30 May 2024
Phoebe Brosnan and Miles Goodman
12 Bassett Street
MONA VALE NSW 2103

Att: Megan Surtees
Northern Beaches Council

Re: Objection to Development Application Number: DA2024/0534,
14 Bassett Street, Mona Vale.

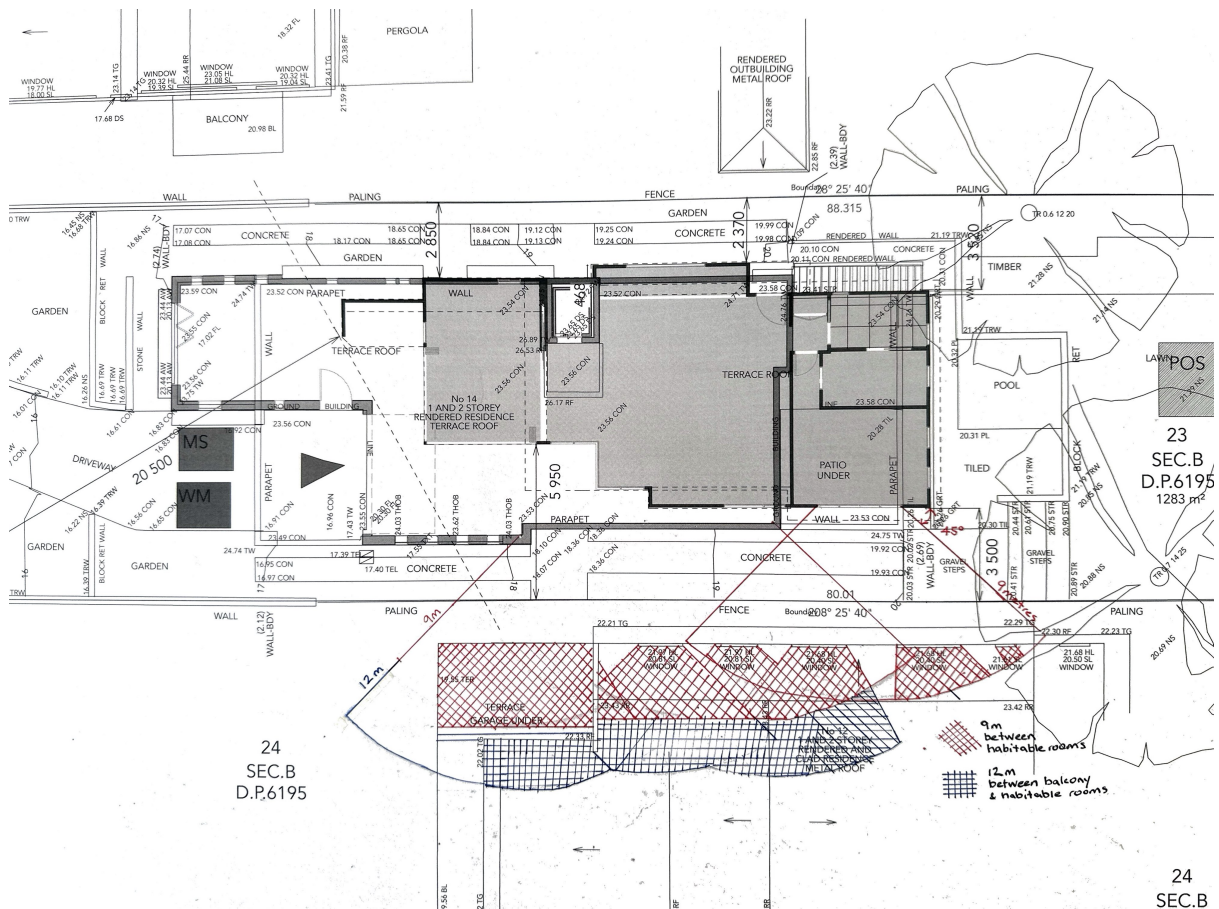
b) Replacing the parapet with glass balcony railings will impact privacy

The proposed removal of the solid parapet wall would have a significant impact on our privacy allowing overlooking of our private open space, living room and all three bedrooms from a side-facing terrace 15 metres long. These photos show how the extension would look directly into our beds.
